Reference: Division of Facilities Construction and Management
New North Ogden Liquor Store and Demolition And Replacement Of The
Ogden (Patterson Avenue) Liquor Store
DFCM Project Nos. 04242030 and 04180030

Subject: **Addendum No. 4**

Addendum No. A04

**New Harrisville, Ut Liquor Store
Department of Alcoholic Beverage Control
433 North Main Street, Tooele, Utah
DFCM Project No. 04242030**

AS
101

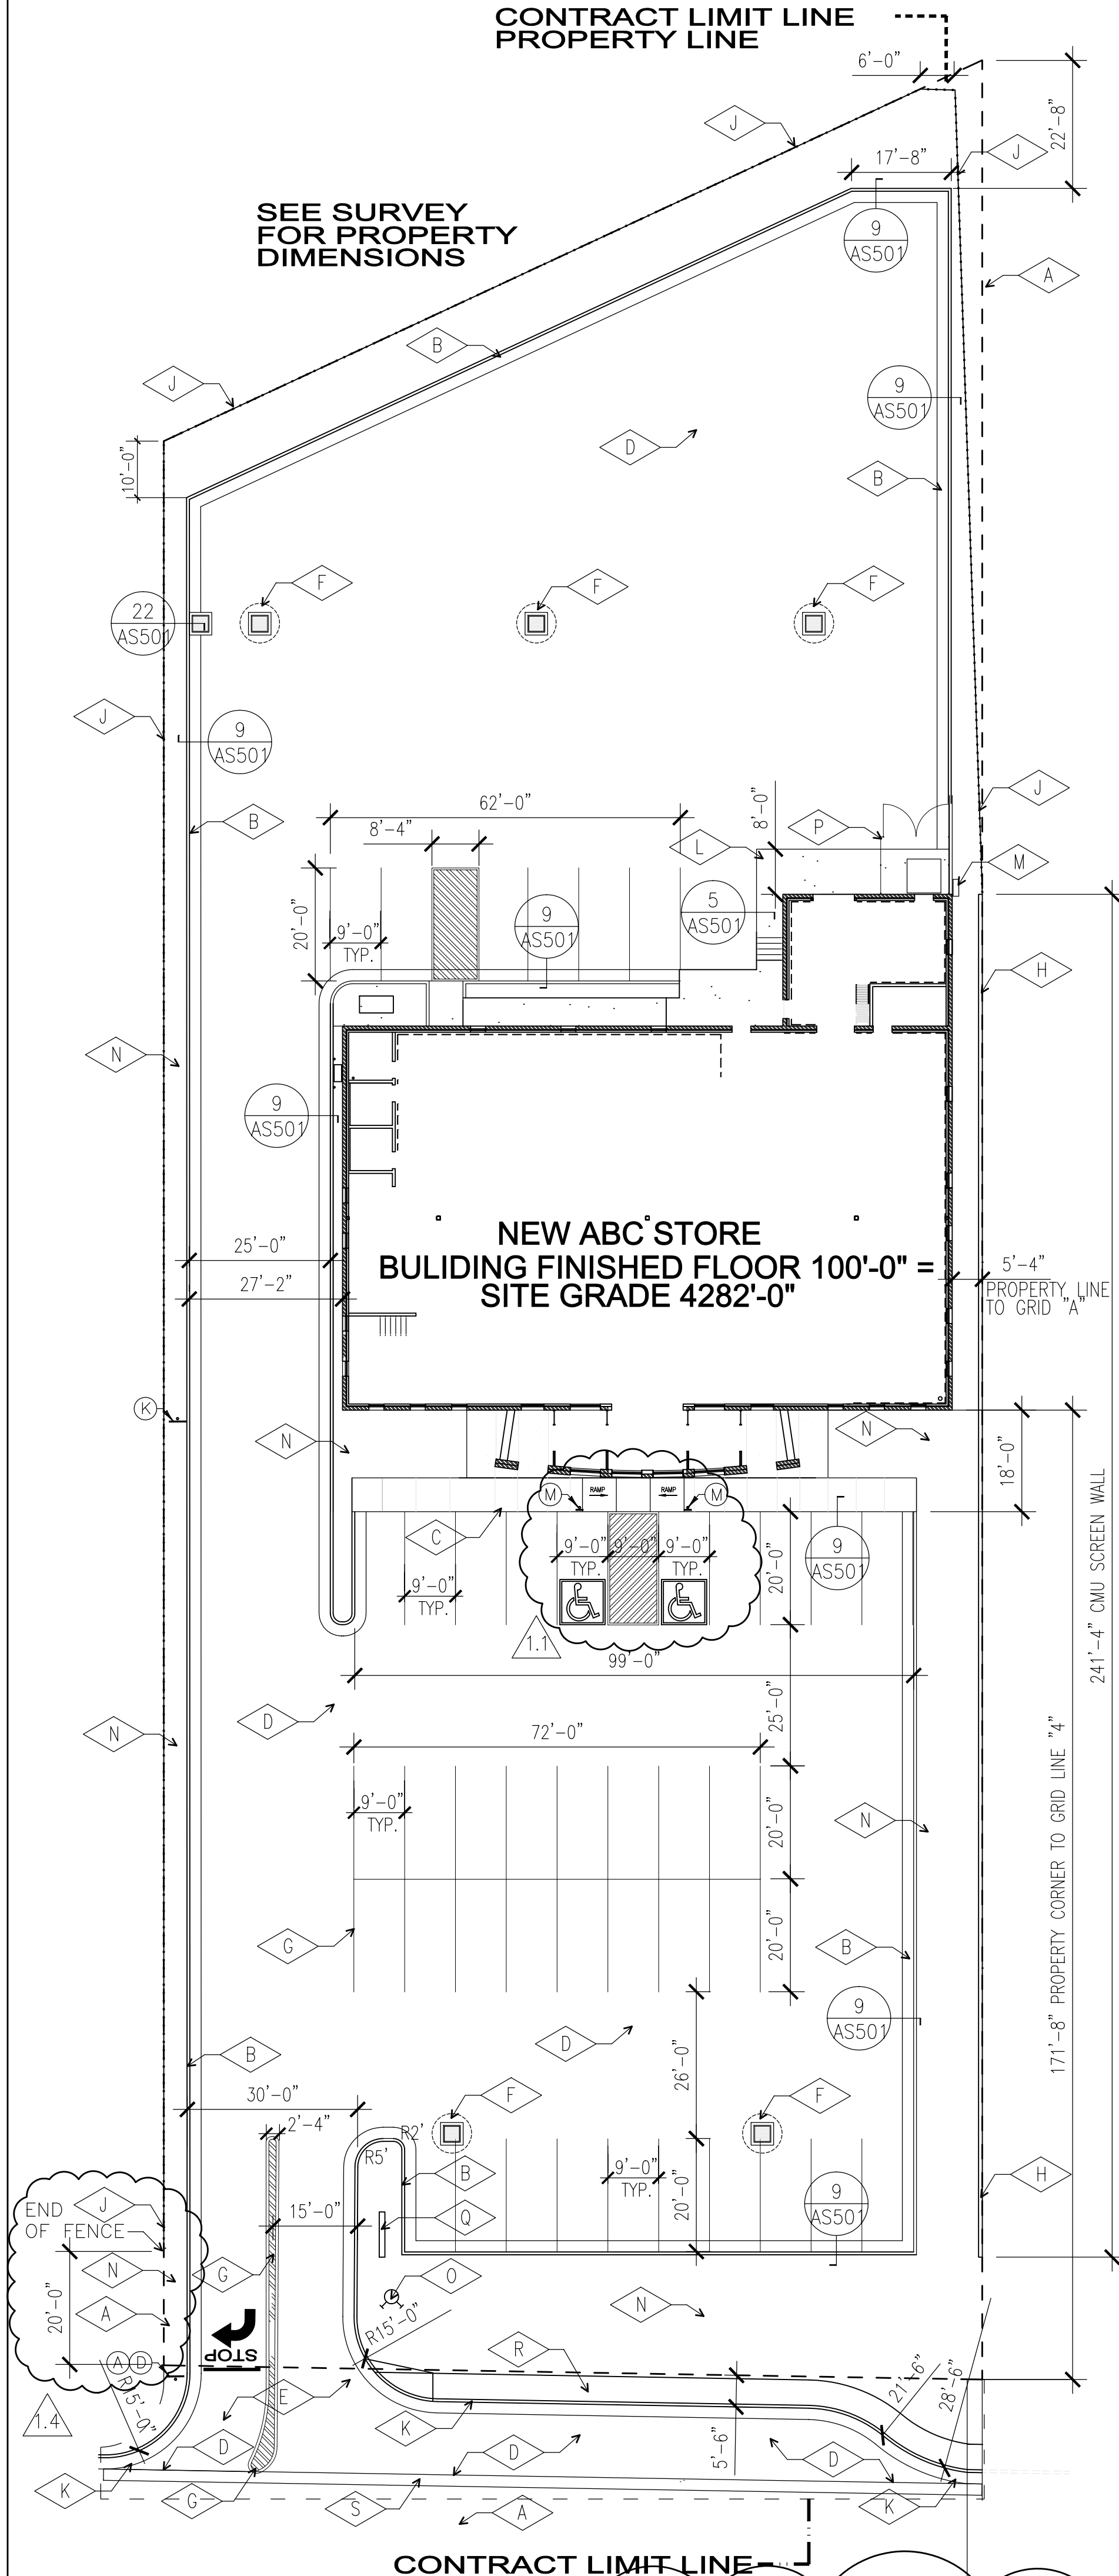
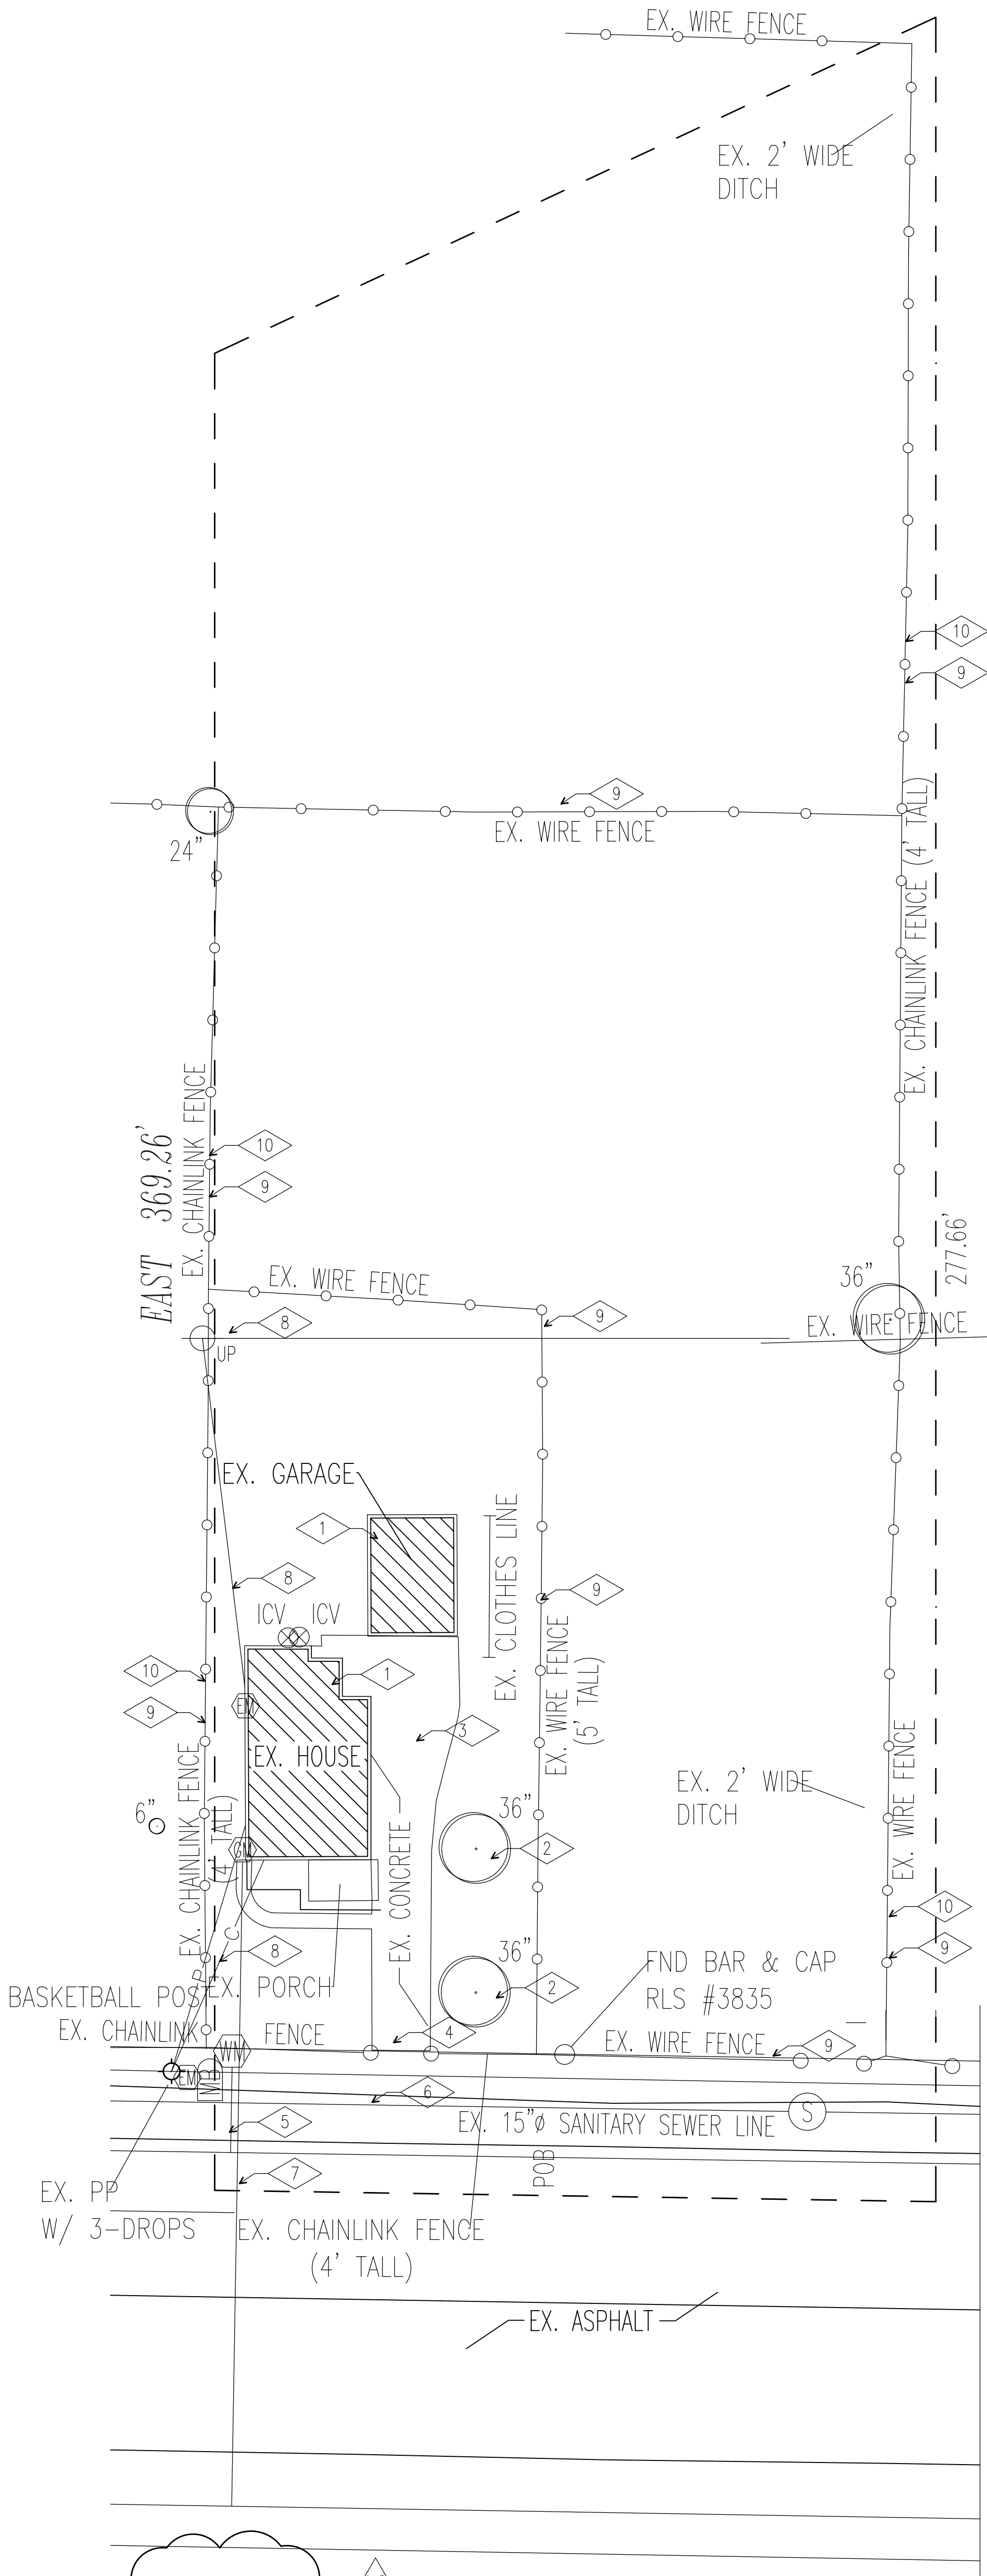
Drawing AS101 has been re-issued with the following changes:

- 1.1 The handicap parking stalls have been modified and clouded. The built-up curb ramp has been eliminated and the sidewalk has been modified to provide a ramp to either direction (see Drawing AS501, note 2, below).
- 1.2 The north arrows have been rotated and clouded to reflect the correct orientation of the building and the site.
- 1.3 "Reference Note J" has been changed to reflect the location and description of the vinyl fence.
- 1.4 The termination of the vinyl fence on the north property line has been dimensioned and clouded.

REFLECTED CEILING PLAN
SCALE: 1/8" = 1'-0"

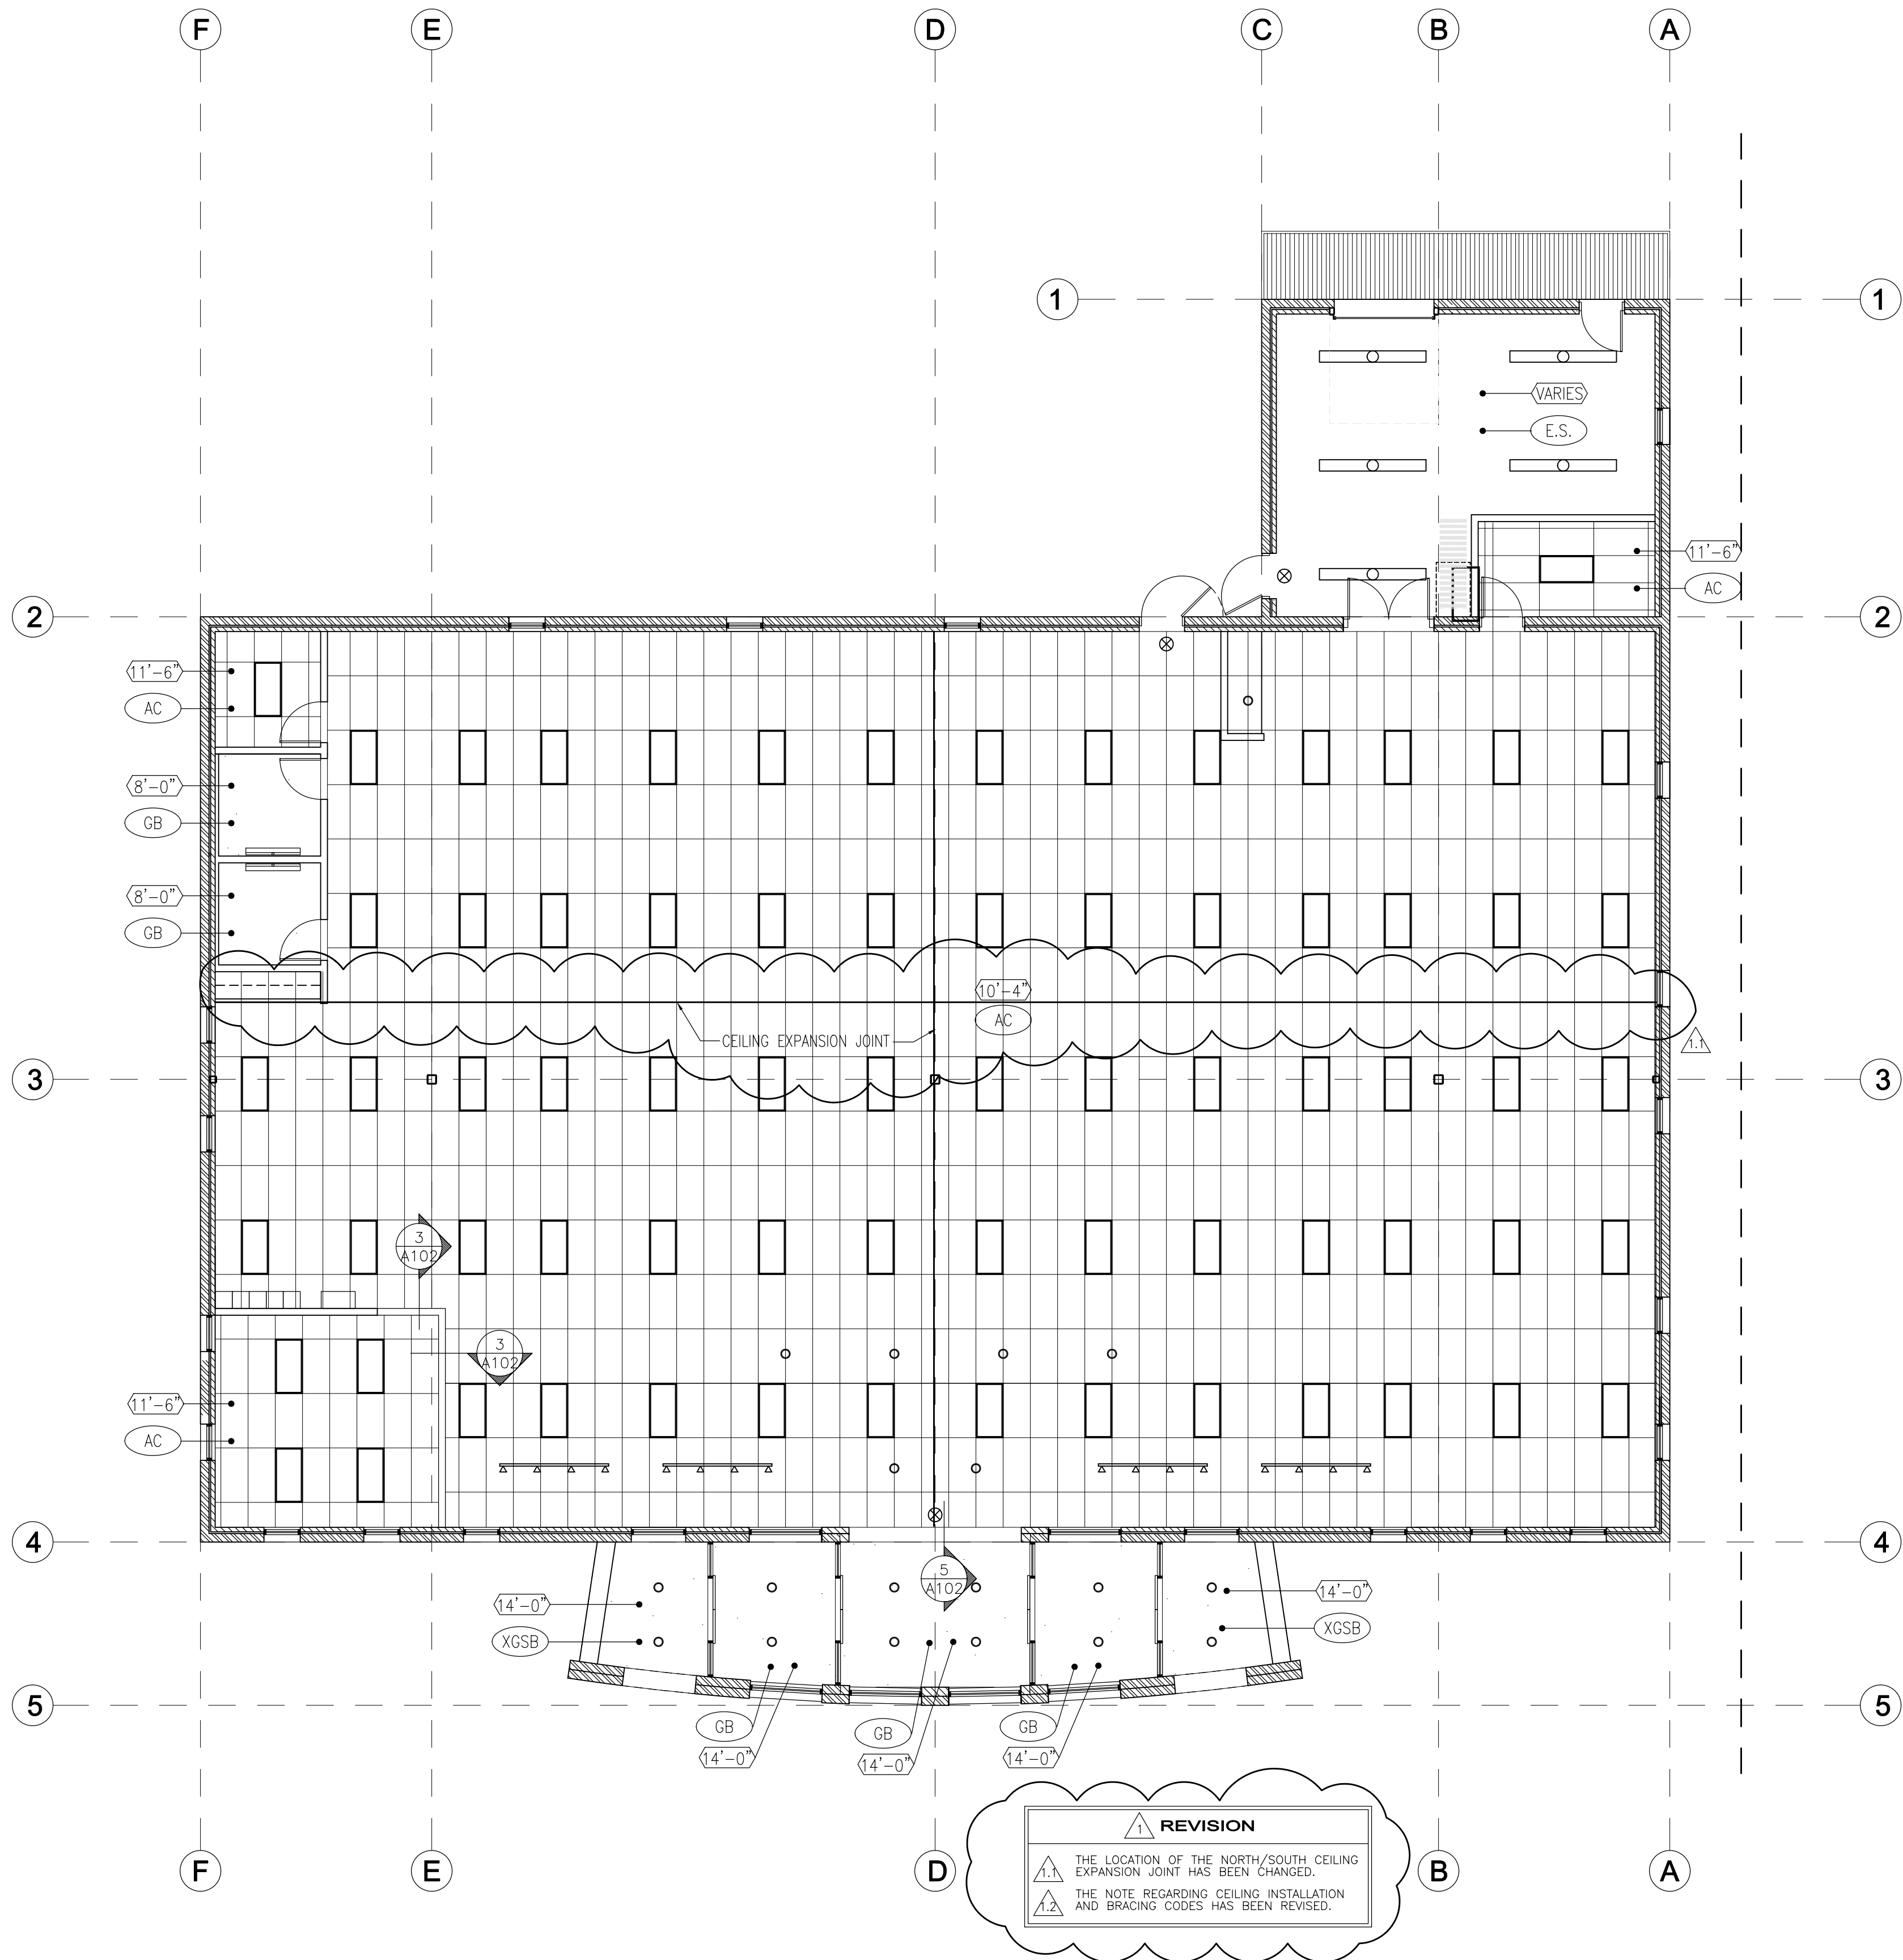
Drawing A102 has been re-issued with the following changes:

- 1.1 The location of the north/south ceiling expansion joint has been changed and clouded.
- 1.2 The note regarding ceiling installation and bracing has been revised and clouded.
